PACKET OF PUBLIC COMMENT ADDENDUM

Advisory Plan Commission

July 6, 2015

RE: 1506-PUD-09 (“Tamarack PUD”)

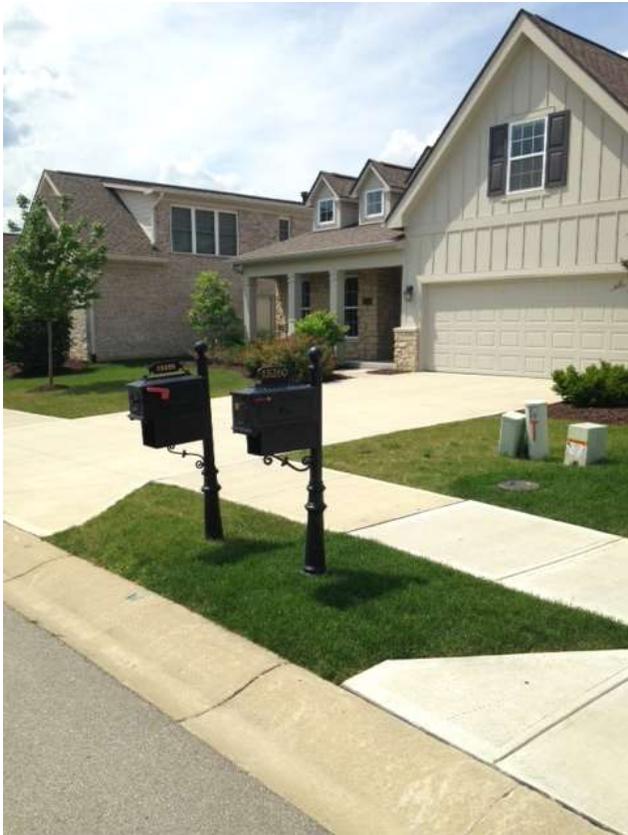
Mr. Hoover and other council and commission members. I have received the latest proposal from the petitioner regarding the Tamarack PUD. I appreciate the latest added provisions prohibiting out buildings and a minimum of 25% basements. However, the petitioner stopped short of addressing one of our other basic concerns. The requirement for side load garages. During the last proposal the petitioner compared their development with the Bridgewater empty nest communities. I took some photographs the other day of the Bridgewater empty nester community off of 151st and Gray Rd. It appears they were able to achieve a 2/3 side load garage community without sacrificing the spacing of the structures on the lots. Please see the attached photographs and please enter this into the record.
